SUBJECT: January 27, 2026 HISTORIC PRESERVATION COMMISSION MEETING

STAUNTON HISTORIC PRESERVATION COMMISSION

HSF Recommendation

815 West Beverley Street

PROPOSED EXTERIOR RENOVATIONS
for
ARCADIA PROJECT-DIXIE THEATER

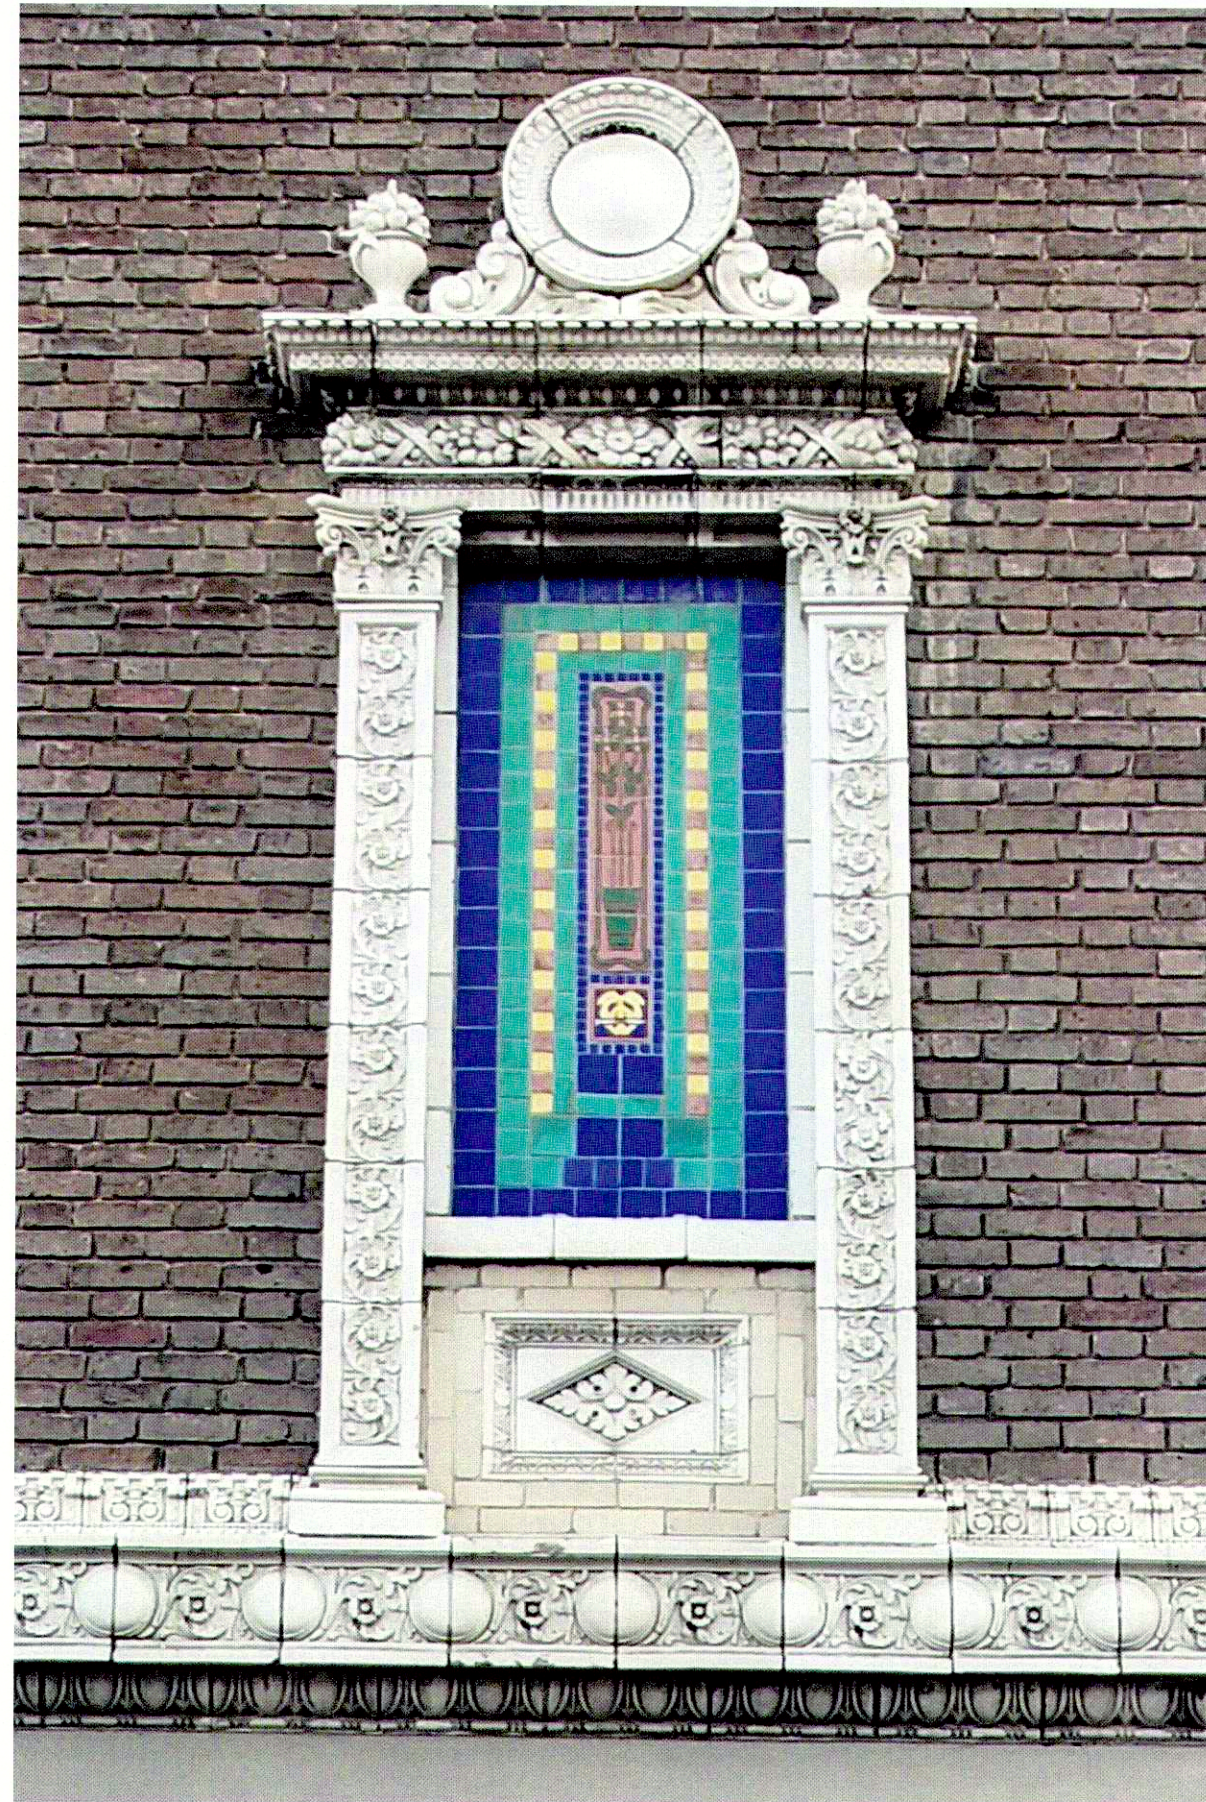
1. Replace the existing flush hollow metal exterior doors on the Beverley Street and Market Street facades with new hollow metal and full obscure glass panel doors. The metal portions shall be painted to match the color of the existing wood entry doors.

4. Replace the existing utilitarian style wall mounted light fixtures, located above the exit doors, on the Market Street facade with new shaded light fixtures in a design that is more appropriate with the design of the building and compliments the design of the signage brackets.
